# **The Town of Hilton Head Island Regular Design Review Board Meeting**

# DESIGN TEAM/ DRB COMMENT SHEET

CIRCLE K STORE # 8100  
NARRATIVE  
REDEVELOPMENT FLOATING ZONE REZONING  
DRB CONCEPTUAL APPROVAL  
August 12, 2011

## DESIGN TEAM/DRB COMMENT SHEET

Rendered Elevations  
of ATM

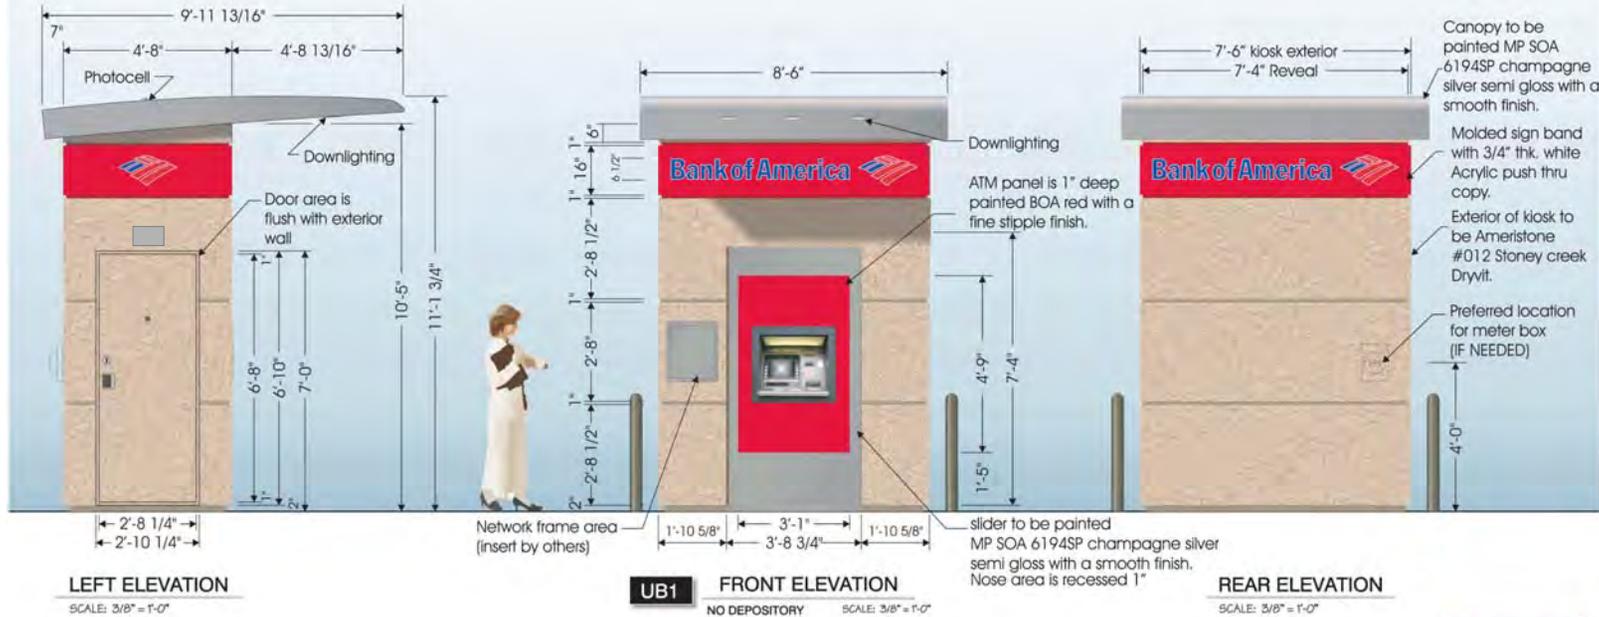
- Stucco should be painted to match that on shopping center
- No color proposed on bollards, but they should remain bronze, as rendered
- There is no roof color to honor, although the same treatment in a bronze finish might be a better reflection of the design guide
- Proposed additional lights posts will need to meet the lighting ordinance. If they are approved, however, the post should match that of the adjacent fixture
- “BOA red” would normally be reviewed as too vivid. Perhaps a deeper red would be more appropriate, or another color complementary to the stucco. The use of the red in the logo is limited and generally acceptable

## CONCEPTUAL REDEVELOPMENT SITE & LANDSCAPE PLAN

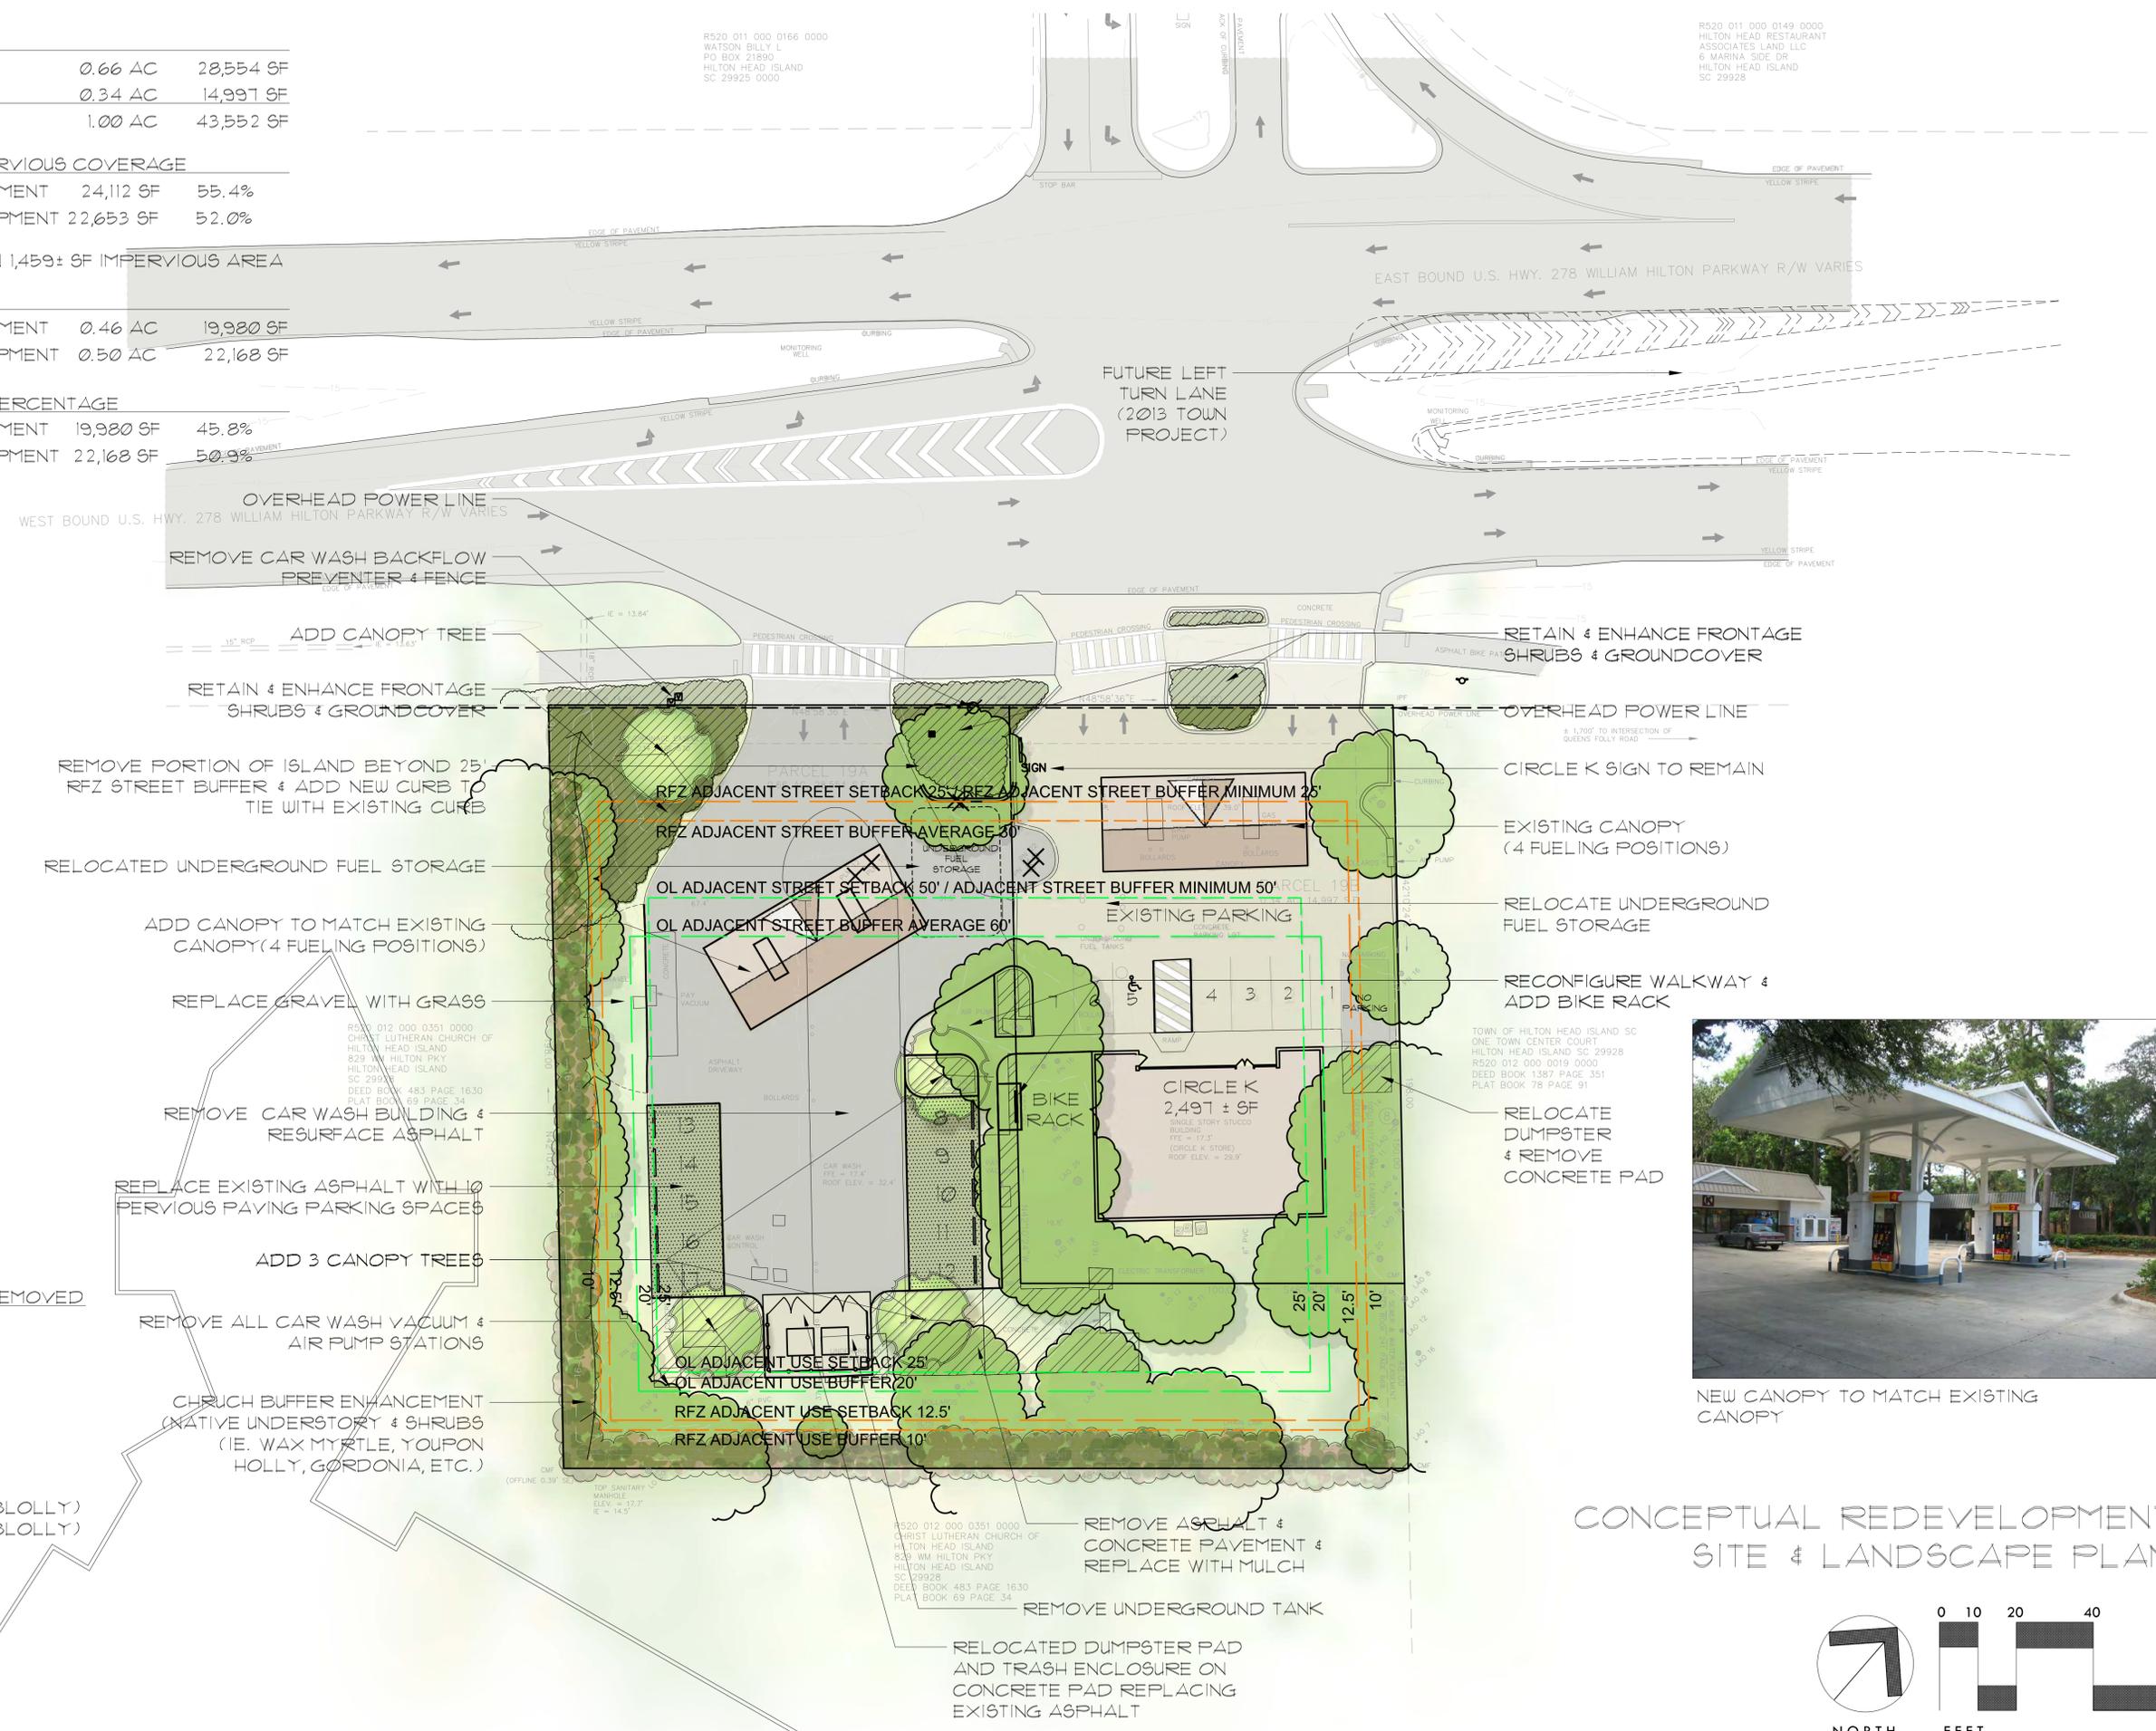
One component for the Rezoning is a “Conceptual Landscape-Buffer Review”, which is an element of this conceptual review. One thing that does jump out is the removal of some significant trees at the street-front area, including two large pines, and 28” of live oak. In establishing and reinforcing the buffer for this new project, some additional trees, of the same nature as the over-story trees proposed, in the vicinity of William Hilton Parkway might be appropriate. Any additional understory planting at the rear where the removal of pavement is proposed would be a better alternative to mulch, where feasible.

A full plant schedule will be needed for review and Final approval.
